**WOODLARK GOLD PROJECT:  
ADDENDUM TO ENVIRONMENTAL IMPACT STATEMENT  
2018**

In parallel with the preparation of an updated feasibility study for the project, Geopacific submitted a request on the 18<sup>th</sup> May 2018 to make some amendments to the Environment Permit following some modifications and improvements to the project.

**Figure 4: Detailed Site Layout**

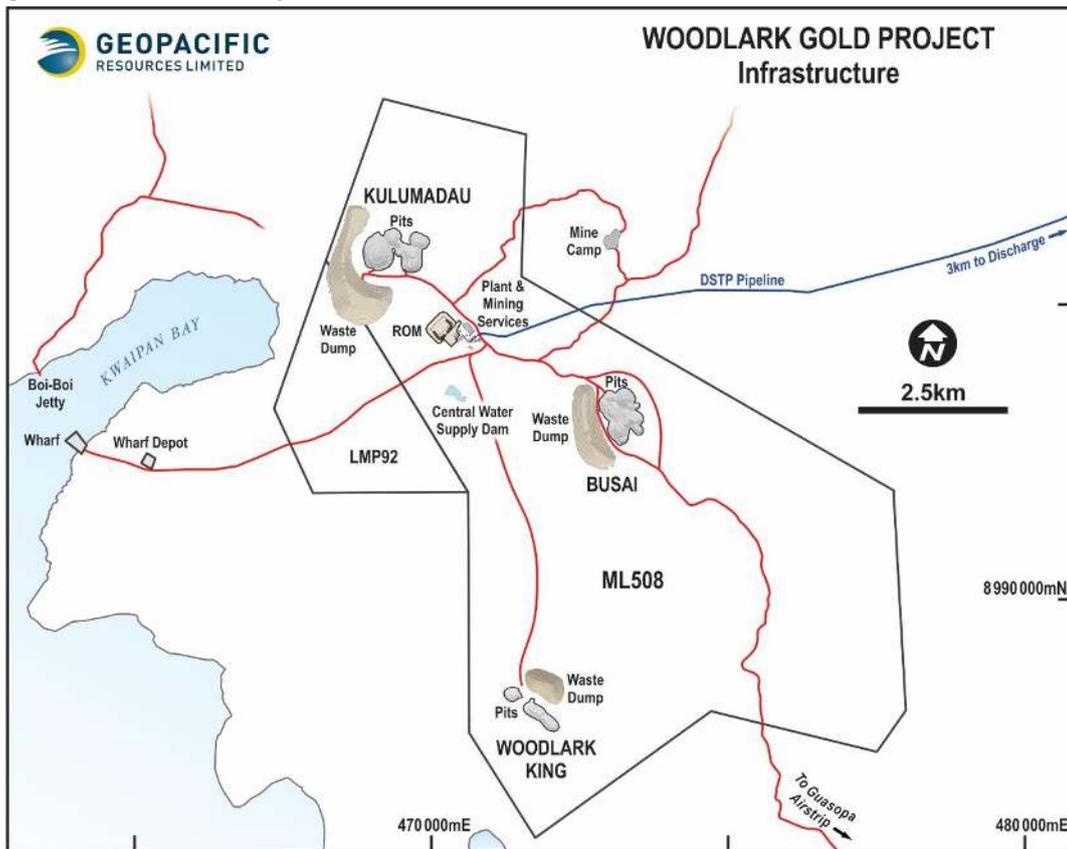
The conventional carbon in leach process plant design and footprint remain fundamentally the same as that described in the EIS. The only material change is that the location of the plant has been moved to a location approximately half way between the Kulumadau and Busai pit areas (see Figure 4). The reason for the move was to improve project economics by reducing overall haul distances. From an environmental perspective, this will result in a reduction in overall vehicle emissions during the life of the project and will reduce overall clearing requirements. Further metallurgical studies have resulted in significant reductions in process water (~45% reduction) and power (~20%) requirements of the plant.

**Figure 5: Old and New Waste Dump and Pit Footprints with Key Drainage Lines**

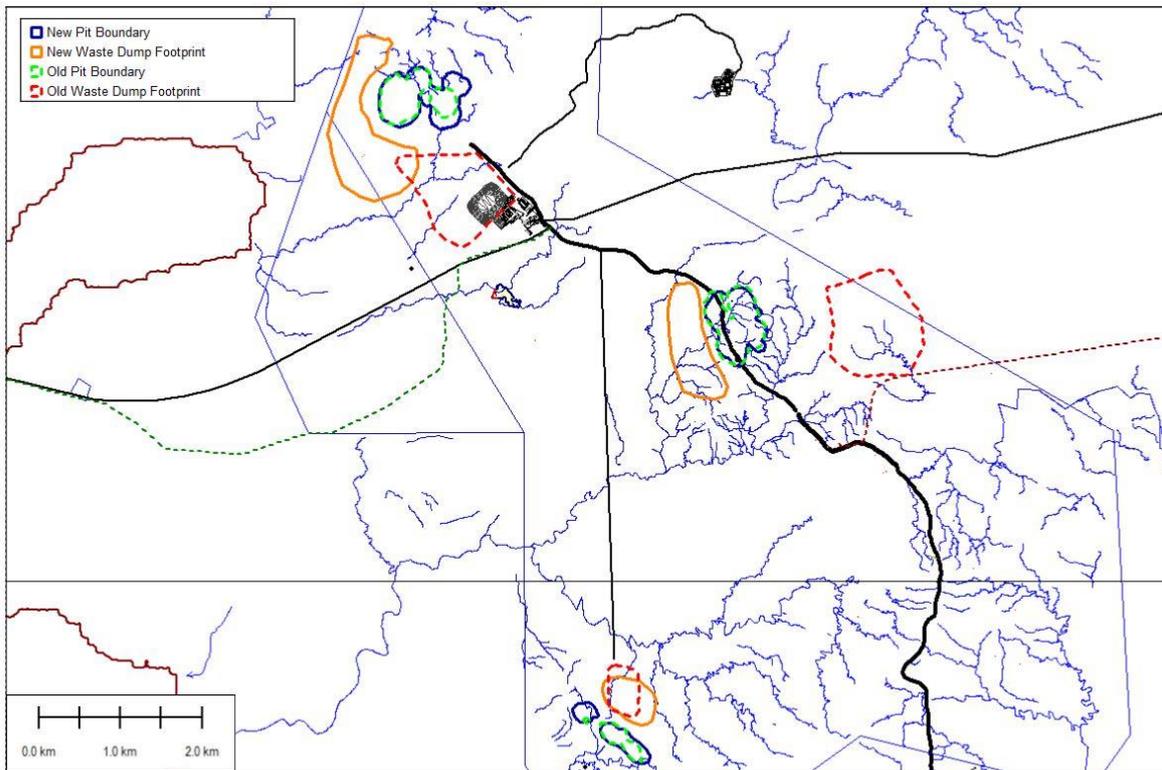
There are proposed changes to the placement and geometry of the three waste dumps (see Figure 5).

The Busai Waste Dump has been moved from its original location of approximately 1 km to the north-east of the Busai pit to a location immediately to the east of the Busai pit. The movement of the Busai waste dump from east of the Busai pit to immediately west of the Busai pit will remove any project infrastructure, other than the DSTP pipeline, from the Bwalei Creek/Lufuai River catchment, significantly reducing the risk of impacts to that catchment.

The dimensions of the Busai and Woodlark King pits have only been marginally altered, primarily due to mine planning and geotechnical reasons (see Figure 5).

Kulumadau was previously planned as two separate pits. Recent drilling has identified additional resource in this area and as such the pit areas will eventually be merged to one area, with the overall boundary being marginally larger than previously expected. There is no additional impact predicted as a result of this change, however further geochemical analysis will be undertaken shortly as per the conditions of the Permit, with kinetic geochemical testing to be undertaken prior to commencement of operations.

**Figure 6: Old and New Wharf Road Alignments**

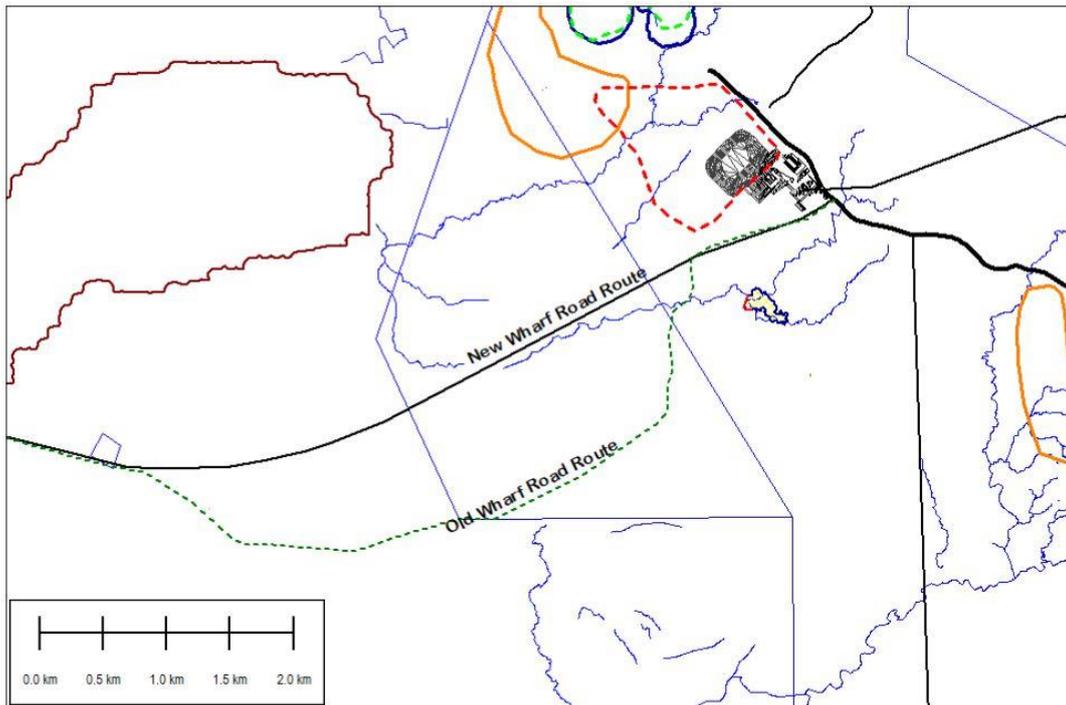
Previously the Wharf Road had been planned to follow an existing logging track. However, for safety reasons and to minimise transport distances the planned route has been realigned to create a shorter, straighter road (see Figure 6). An application for an amendment to the Lease for Mining Purposes is currently being prepared and will be submitted accordingly.

The total road length is approximately 5.8 km and will have a width of 5 m and total cleared width of 12 m to allow for transport of wider items. Construction will comprise two 150 mm layers of coronus material roadbase with culverts emplaced on drainage channels.

**Figure 7: Old and New DSTP Alignments**

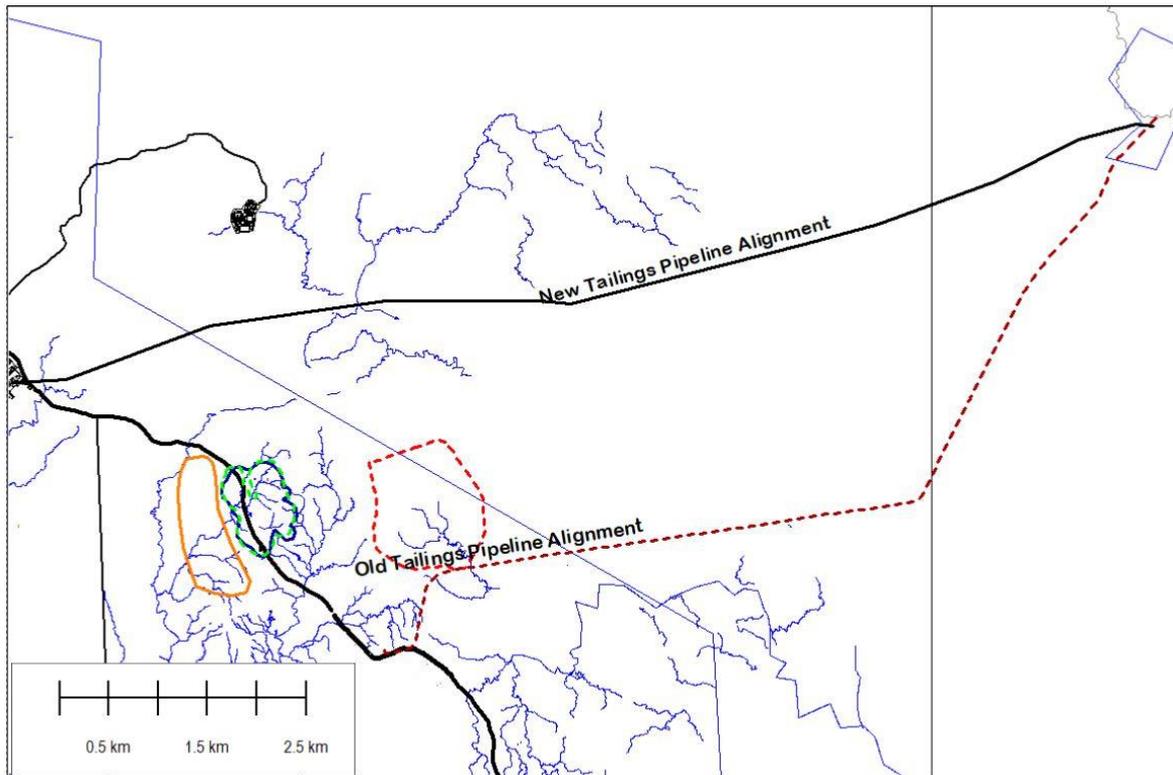
Due to the new proposed location for the process plant the DSTP pipeline has been realigned (see Figure 7). The realignment will reduce the overall pipeline length from approximately 14 km to 11 km and also avoid crossing a significant creek which would previously have been impacted. An application for an amendment to the Lease for Mining Purposes is currently being prepared. The new proposed route for the DSTP pipeline is now positioned at the upper reaches of the Bwalei Creek/Lufuai River catchment where drainage lines are significantly smaller, significantly reducing the risk of the pipeline being affected by flooding events.

It was previously proposed to construct the overland pipe as a “pipe in pipe” construction. Further investigation however has concluded that the benefits of pipe in pipe are negligible if the purpose of the outer shell is for fluid containment purposes only (typically pipe in pipe construction is done primarily to provide insulation to the inner pipe). Pipe in pipe also has significant limitations when it comes to condition monitoring and failure detection (i.e. if the inner pipe fails it would not likely be identified until the outer pipe also fails). For this reason, it is preferred to construct the pipeline as a single line, utilising bunding for pipeline protection. The proposed pipeline has been designed to ensure a high safety factor should it become over pressurised for any reason. The maximum predicted operating pressure along the pipeline is 5.1 bar with the pipeline rated to 8.9 bar at 50°C.

**Figure 16: Predicted Impacts to Freshwater Streams (2018 Modelling)**

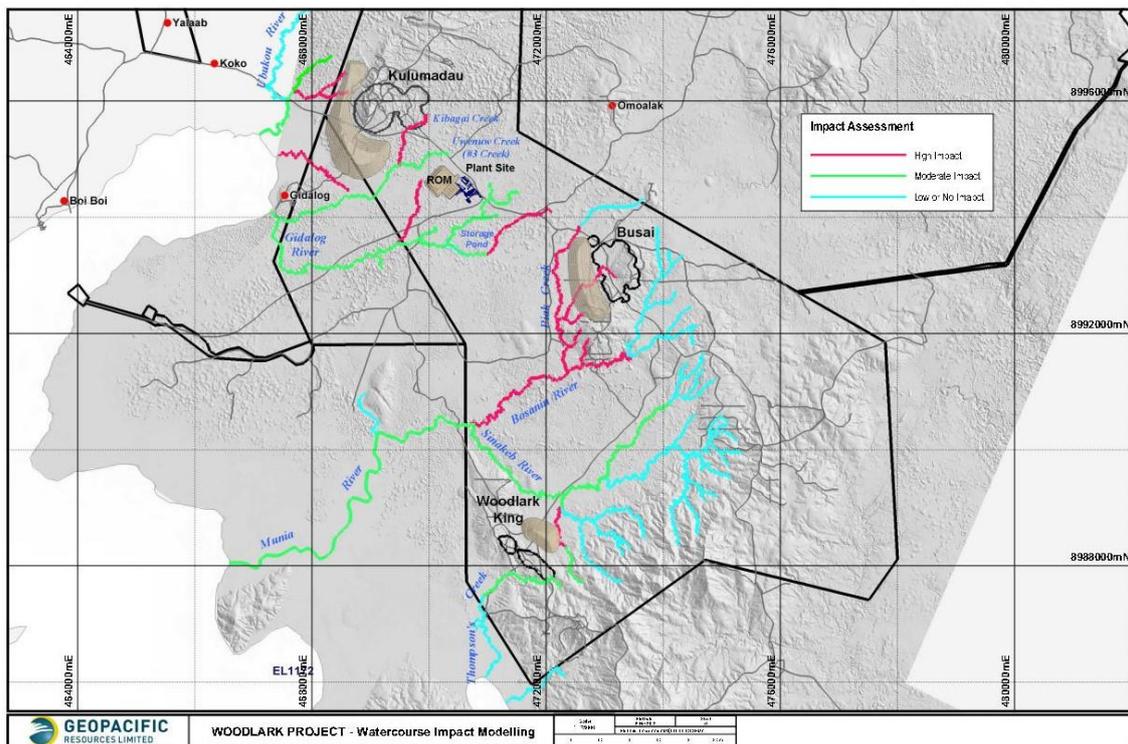
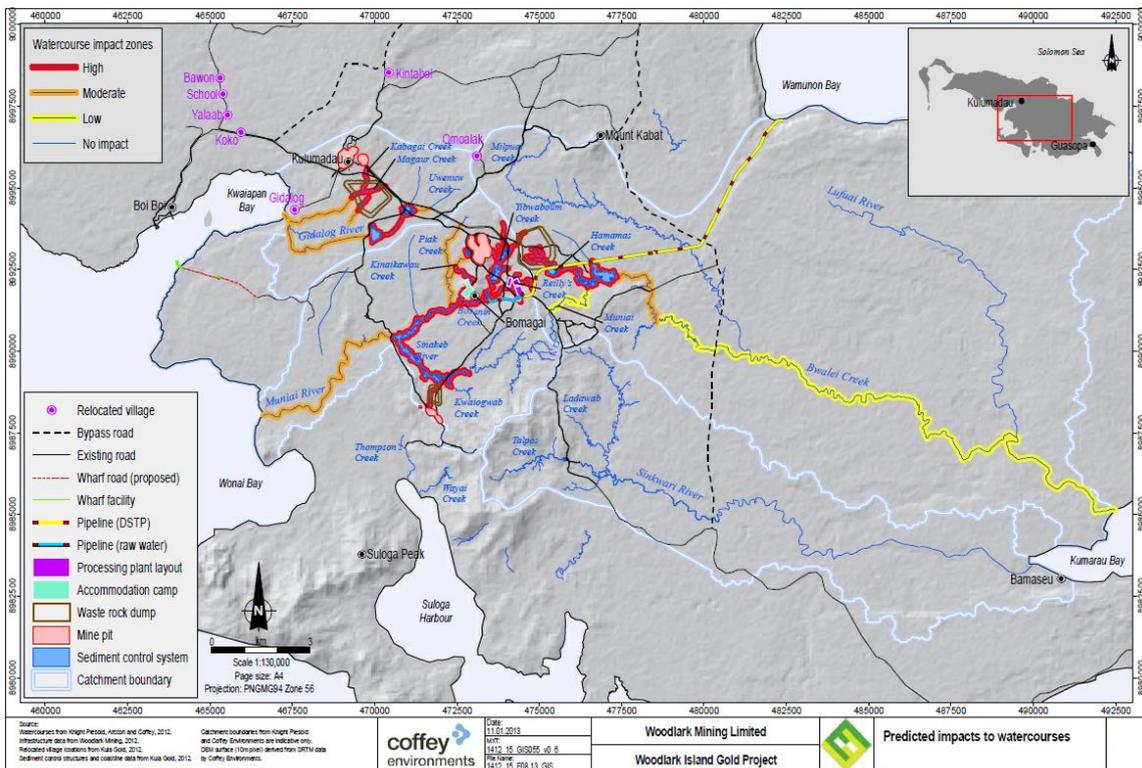
As noted in Section 8.1.4, additional sediment modelling has been completed by consulting firm DHI. The results of the DHI modelling have been used to delineate areas of high, moderate and low severity impacts to the downstream environments. Areas are shown in Figures 16, with the results presented in the 2013 EIS provided in Figure 17 for comparison.

As noted in the EIS, the impacts to freshwater environments will range from high severity to no impact depending on proximity to areas of disturbance. The shifting of the Busai waste dump will significantly reduce the impact to the Bwalei Creek/Lufuai River catchment, removing all of the high and moderate severity impact areas from this catchment. The broader strategy of avoiding larger creek lines where possible to allow natural flow has reduced the level of impact in some creeks adjacent to all three mining areas, however the downstream areas of Gidalog and Muniai Creeks will remain classified as moderate severity impact.

Therefore, the approved EIS presents a conservative assessment compared to the present so there is no major change to the impact assessment.
